Date: October 18, 2012
To: Merrick Turner
From: Andrew Dennehy BETA Project #: 4410
Subject: University Station – Utility Information
Required

The purpose of the memorandum is to provide review comments regarding utilities for the October 9th, 2012 preliminary plan submission made by the Proponent in connection with the University Station Development Project.

**Westwood Station
Sewer Extension Evaluation**

Figure No. 3
Siphon Relocation Plan

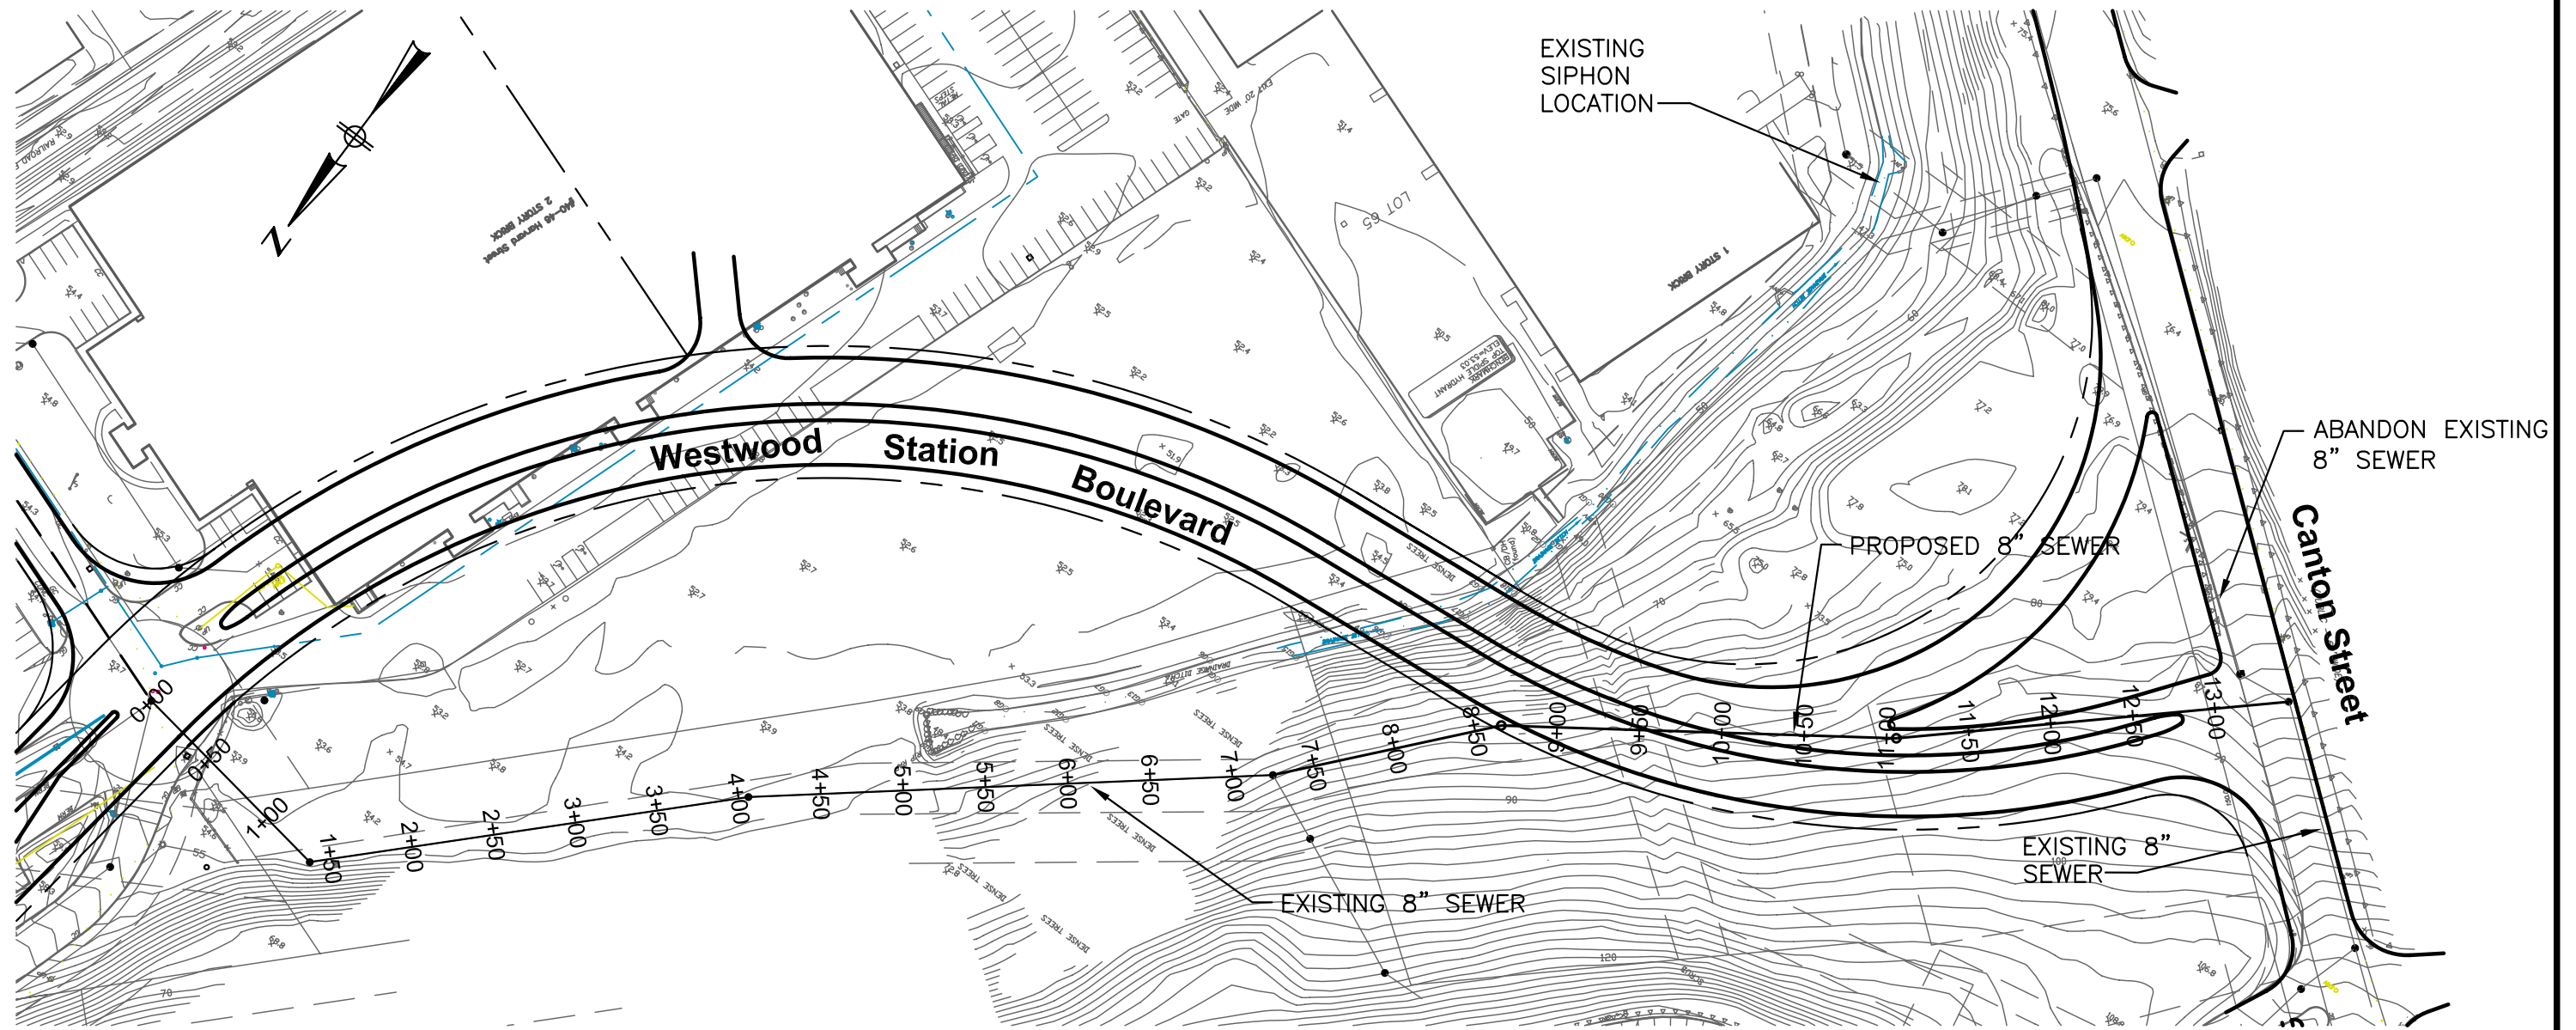
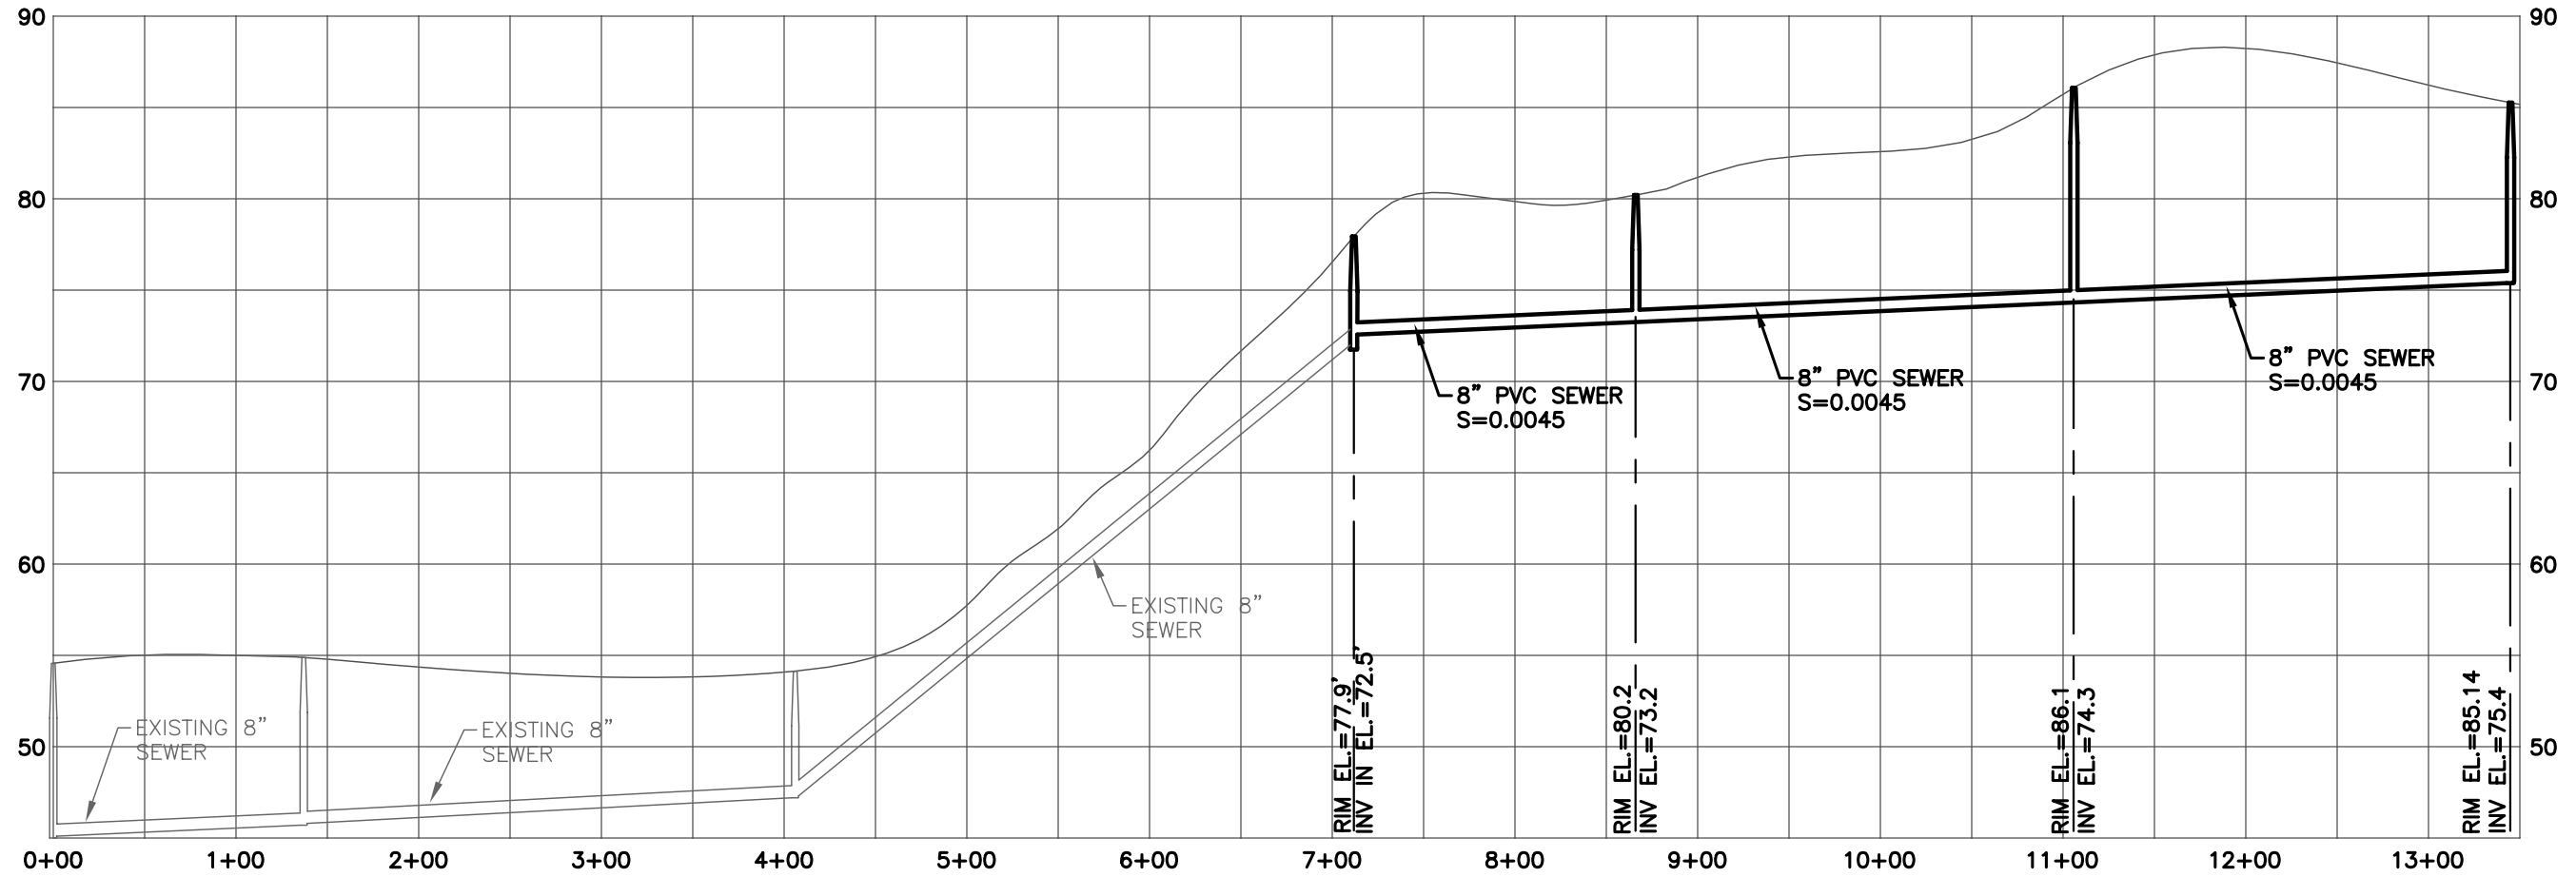
Our analysis of this siphon indicates it is likely feasible to eliminate this siphon. Outlined in **Figures 3 and 4** is a plan and profile for eliminating the need for the siphon. This is not a final design. Should there be any services within the abandoned section of sewer, these services would need to be redirected.

A field investigation was conducted to verify existing record drawings. Approximately 600' of new 8" sewer could be installed to eliminate the siphon.

There are a number of unknowns that need to be addressed in final design. These include determining existing flow in the 8" sewer on Canton Street, and a capacity analysis on the 8" sewer that continues cross-country to Harvard Street. Our field investigation shows that the sewer on Canton Street is flowing 1/3 to 1/2 full, while the sewer running cross-country has minimal flow at the manhole where a new connection would be made. It may be necessary to upgrade sewer sizes. This may be a viable option for eliminating the siphon, and may be worth the cost of upgrade.
